Preliminary Drainage Report

Waterview East Commercial El Paso County, Colorado

PCD Filing No.: SP-22-009

Prepared: July 5, 2023

INLET IN A SUMP OR SAG LOCATION

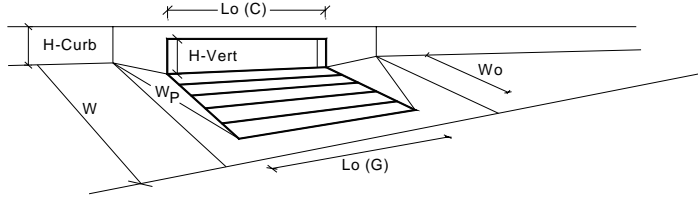
Per drainage plan, cross pans appear to be only 4' wide and 2" deep per standard detail. Suggest using actual cross pan dimensions and determine if minor storm is contained within pan section (can be done at time of final plat). If it doesn't could cause major damage to road.

Waterview East Commercial
Inlet A7

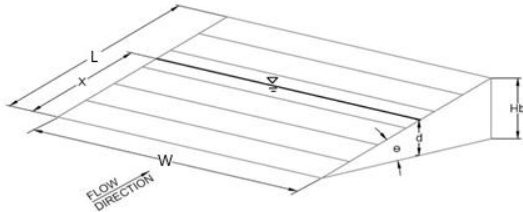
Suggestion: It appears the inlet is not sized adequately. Recommend consider resizing when submitting the Final Drainage Report with the final plat.

WATERVIEW EAST COMMERCIAL
CONSTRUCTION DOCUMENTS
PROPOSED DRAINAGE MAP

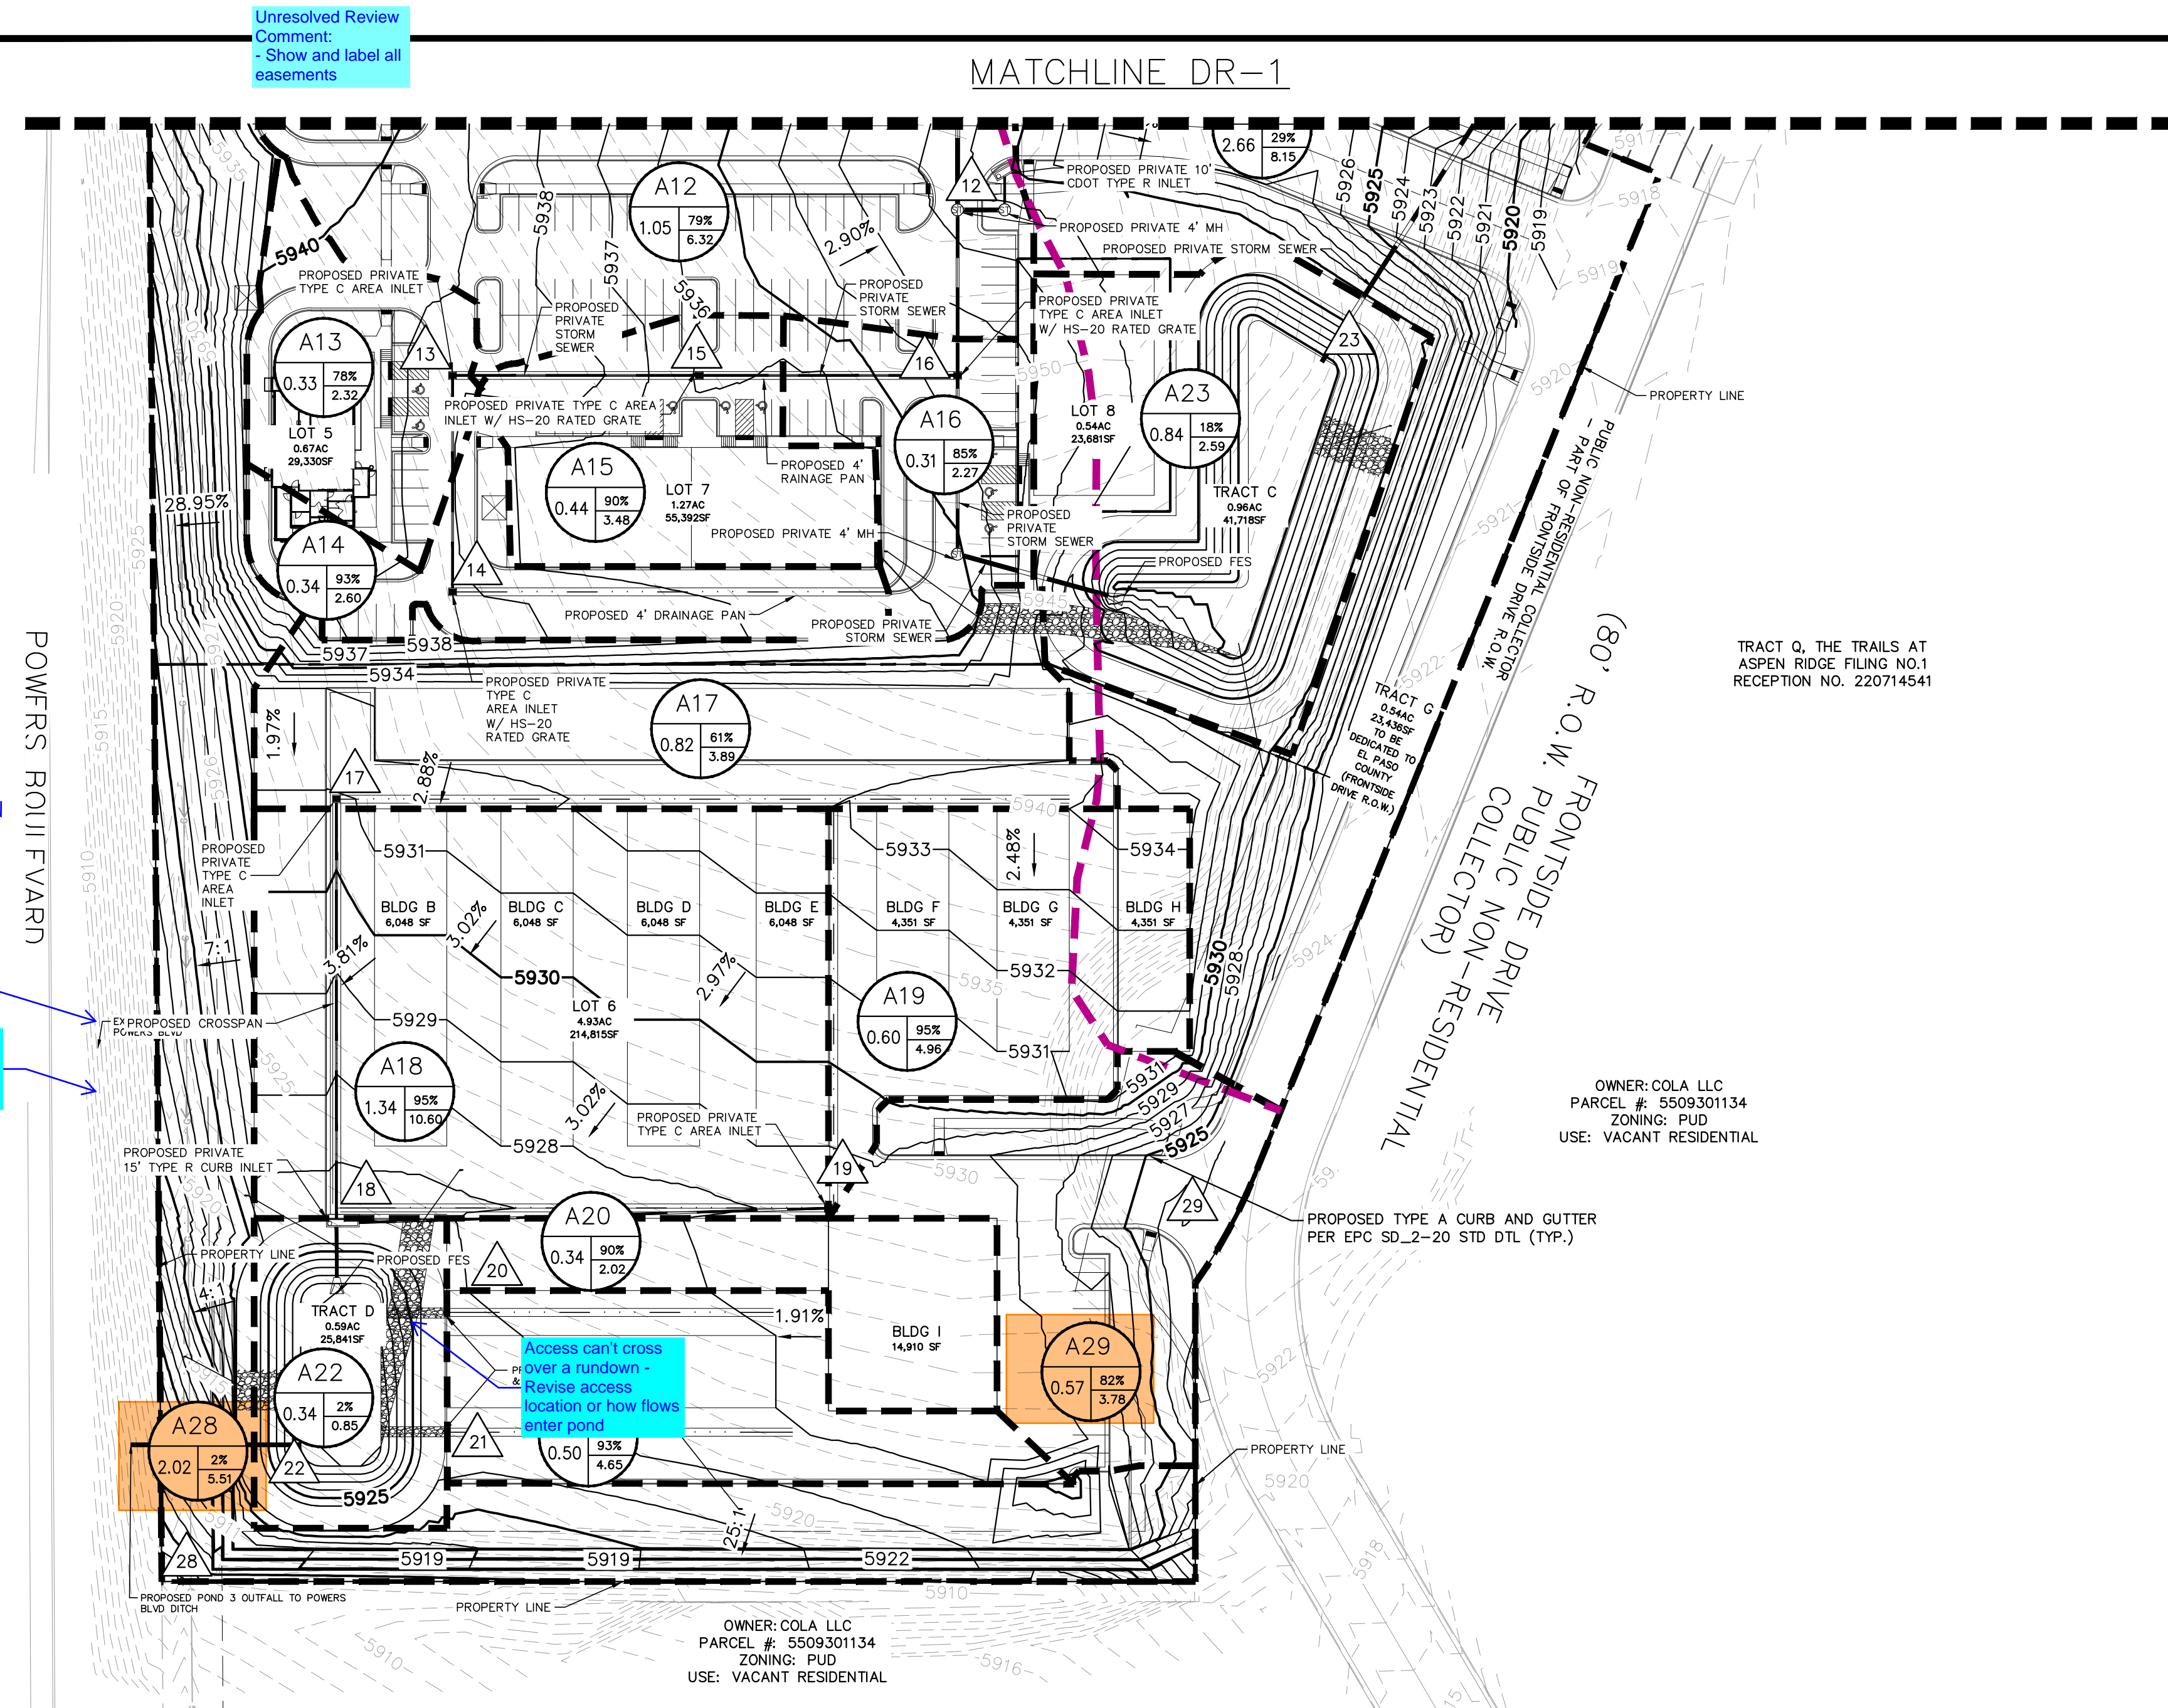
From grading, it appears this portion of the basin will end up in Bradley Road, not the pond. If the intent is to direct the flow to the pond, show how swale at property line makes it around the corner and into the pond

Water Quality treatment and detention for these 3 basins are not accounted for in the PBMP Summary Table. Please revise table accordingly.

Unresolved Review Comment:
- Area does not match with
MHFD spreadsheet. Please
revise and verify all areas
match.

Unresolved Review
Comment:
- Turn flowline for ditch
back on
